<b>Well Name:</b> SUNDANCE FEDERAL	<b>Well Location:</b> T24S / R31E / SEC 5 / SWSE / 32.2408784 / -103.7975664	<b>County or Parish/State:</b> EDDY / NM
<b>Well Number:</b> 32	<b>Type of Well:</b> OIL WELL	<b>Allottee or Tribe Name:</b>
<b>Lease Number:</b> NMNM104730	<b>Unit or CA Name:</b>	<b>Unit or CA Number:</b>
<b>US Well Number:</b> 300153367500S1	<b>Operator:</b> OXY USA INCORPORATED

**Notice of Intent**

**Type of Action:** Plug and Abandonment

NOI TO PERMANENTLY ABANDON THIS WELL VIA CEMENT PLUGGING.

Proposed Wellbore  
**SUNDANCE FEDERAL 032**

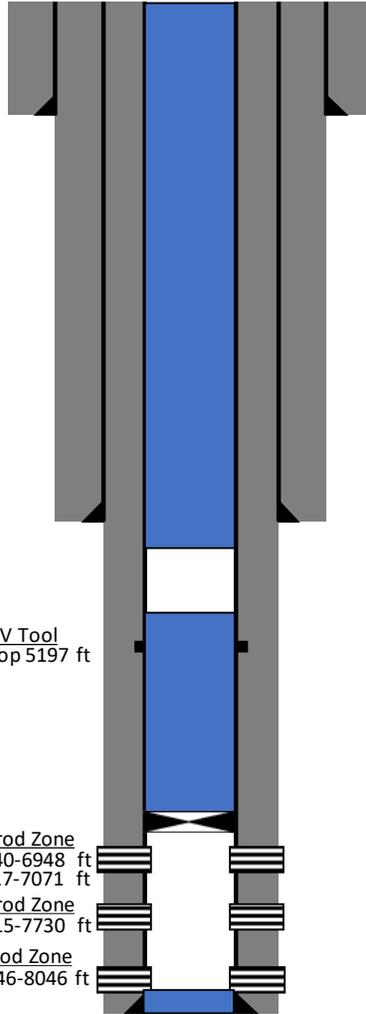
PLEASE REVIEW VOLUMES PRIOR TO PLUGGING.  
WOC AND TAG BETWEEN STAGES IF STAGING PLUGS
